Hazelbrook Station Upgrade

Determination Report

**Transport Access Program
Ref - 6200904**

Figure 2 Modified station building internal layout

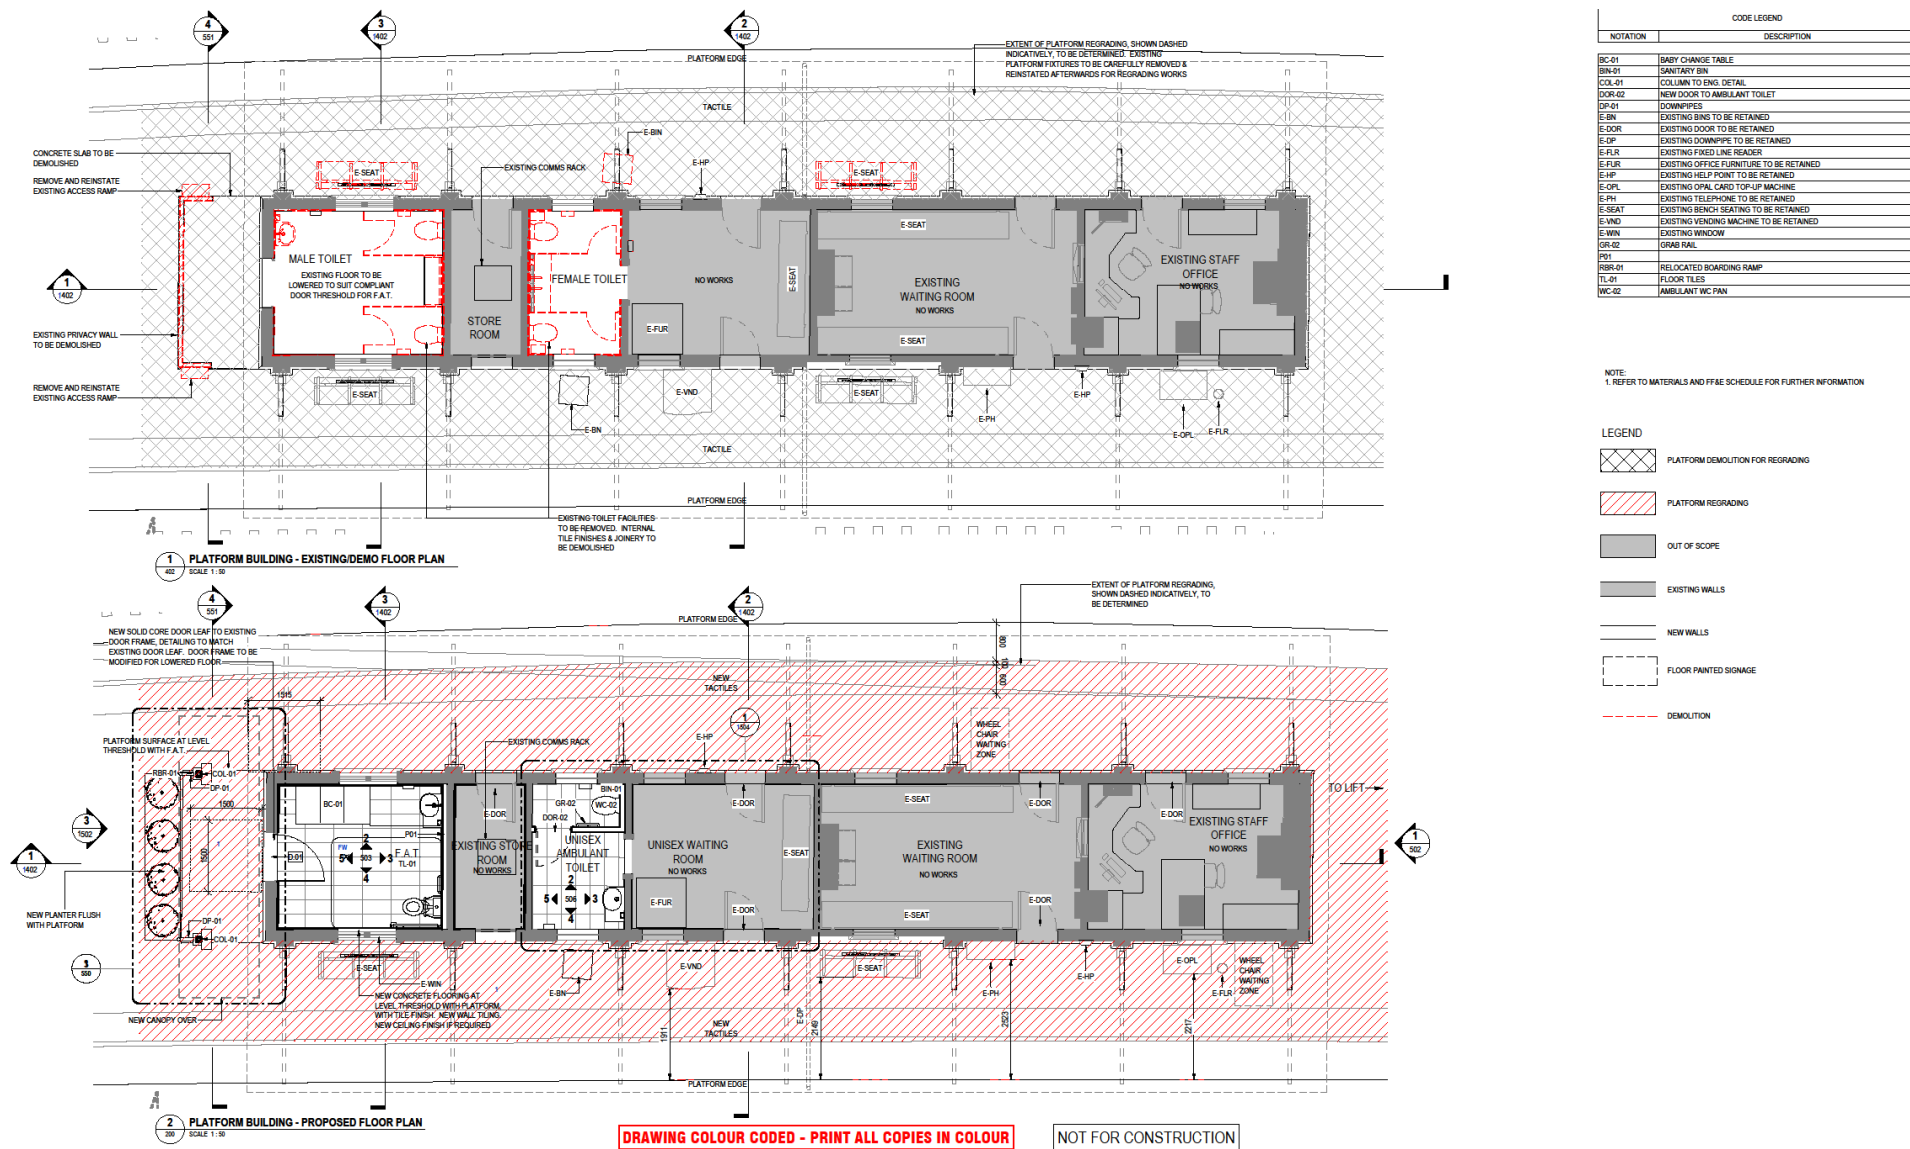
Aspect of the Proposal	Design change	Discussion of impact
Station building	<p>There would be a reduction in the works to the internal reconfiguration of the station building as follows (refer to Figure 2):</p> <ul style="list-style-type: none">• The existing female toilet would be converted to a unisex ambulant toilet• The station services equipment room (SSER) is no longer required• There would be no modification to the existing store room and waiting room area adjacent to the existing female toilets• The existing equipment rack would be used to house communications equipment in the store room (i.e. no change).	<p>The changes related to potential heritage impacts and a heritage assessment has been completed by Extent Heritage (refer to Appendix C). The assessment found that overall, the changes represent a reduction in impacts to heritage values (through avoiding direct impacts to heritage fabric) and amendments and mitigation measures recommended in the <i>Hazelbrook Statement of Heritage Impact</i> (Extent, 2018). Consideration for the revised mitigation measures has been included in the Conditions of Approval 29, 30 and 31.</p>
